COUNTY OF SAN MATEO
ALPINE ROAD TRAIL IMPROVEMENTS PROJECT
TOTAL PROJECT APPROXIMATELY 1.84 MILES IN LENGTH
WITH APPURTENANT WORK THERETO
IN SAN MATEO COUNTY

COUNTY PROJECT NO. P23P1
PROJECT FILE NO. E4905

ADDENDUM NO. 2

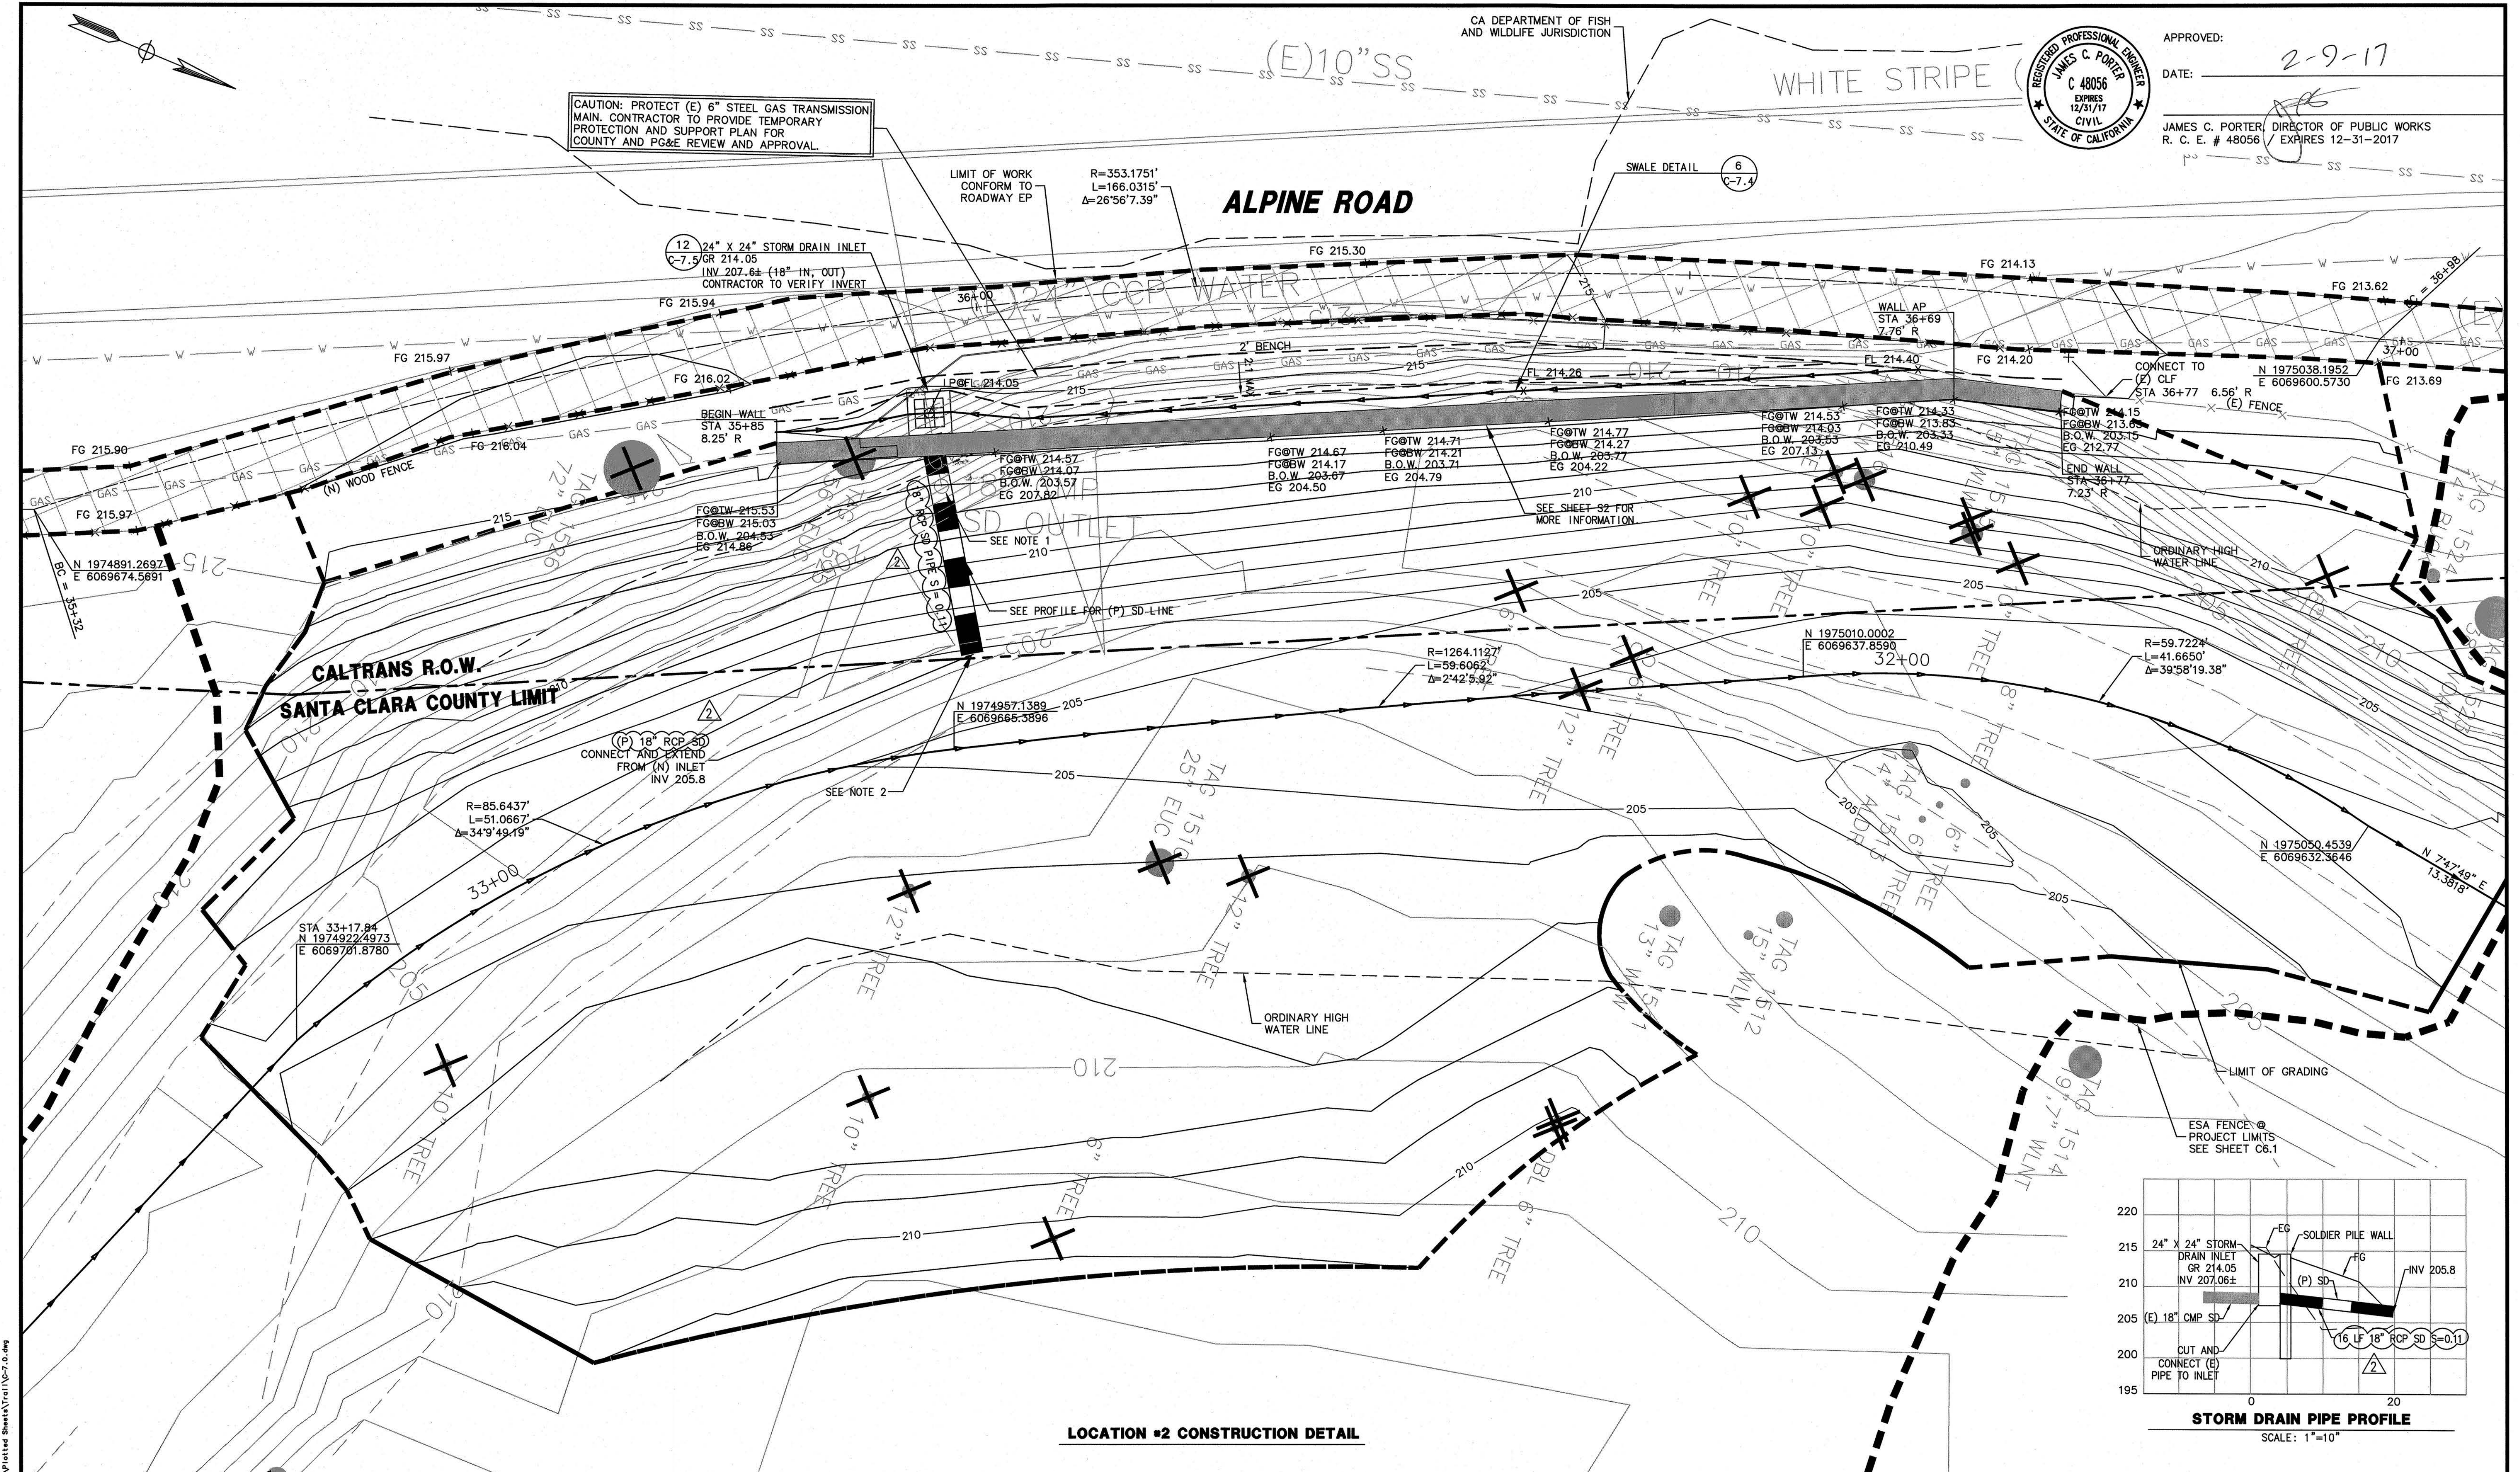
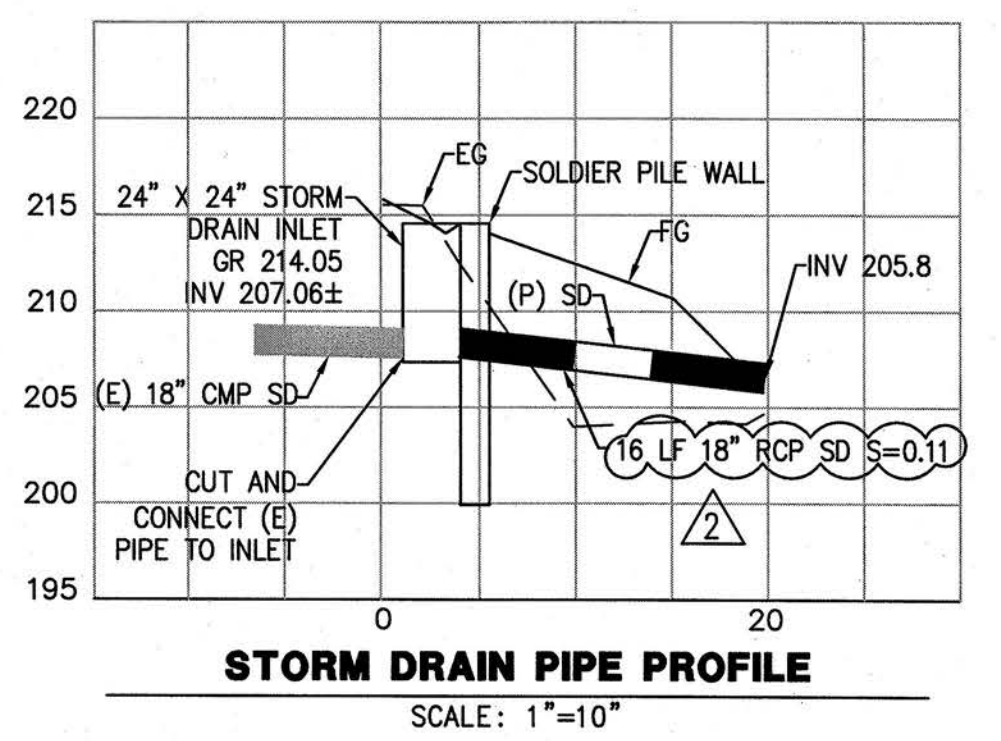
7. Page C-7.1 of the Plans shall be replaced in the Project Plans:

Replace page C-7.1(Sheet 24 of 43) of the Plans with page C-7.1 (rev) (Sheet 24 of 43).

- NOTES
1. THE EXISTING 18" STORM DRAIN CORRUGATED METAL PIPE COLLECTING RUNOFF FROM ALPINE ROAD AND DISCHARGING TO THE CREEK WILL BE CUT AND CONNECTED TO THE NEW STORM DRAIN INLET. A NEW 18" STORM DRAIN REINFORCED CONCRETE PIPE WILL CONNECT TO THE INLET, CROSS THE PROPOSED SOLDIER PILE WALL AND OUTFALL AT THE CREEK. SEE STRUCTURAL SHEETS FOR WALL PENETRATION DETAILS.
 2. REFER TO SHEETS CR-1 TO CR-11 FOR ADDITIONAL CREEK RESTORATION INFORMATION AND BIOTECHNICAL DETAILS INCLUDING SURFACE TREATMENT AT THE PIPE OUTFALL.
